UNITED STATES PATENT AND TRADEMARK OFFICE

10/796,830

Office Action Summary

DETAILED ACTION

FIG. 2c

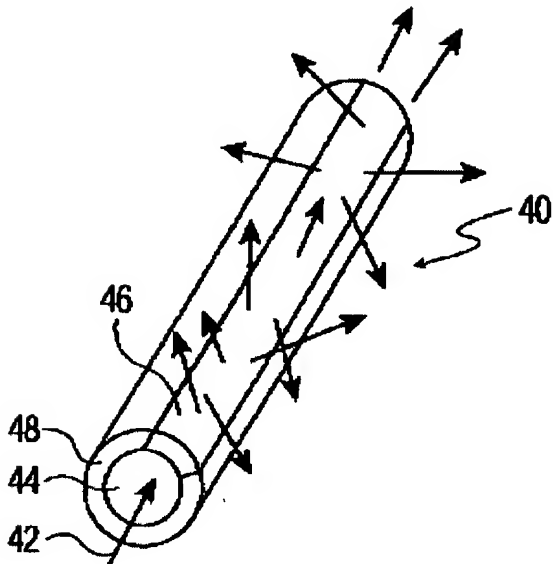
As to claim 1, Imamura discloses a light pipe [col. 6, lines 33-63] with directional side-light extraction, comprising: a) a core, 3; b) light-extraction means, 1, applied to the core over only a part of the cross-sectional perimeter of the core and over an active section in which directional side lighting is desired; and

Applicant's Figure 2c:

Fig. 1

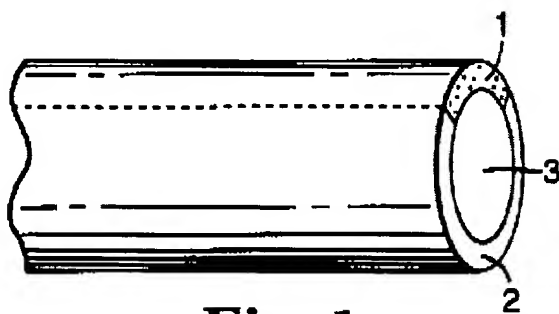
Imamura Figure 1:

c) the light-extraction means comprising a single strip of material, 1, over the active section of the light pipe, said single strip having light-scattering material, the light-scattering material comprising inorganic material [col. 6, lines 51-65] and being

physically discrete from core material and being physically discrete from any cladding material on the core [inorganic particles in a discrete single strip that does not extend into the cladding, 2, on either side and does not extend into the core, 3].

Imamura does not explicitly disclose in Figure 1 a strip comprising a substrate.
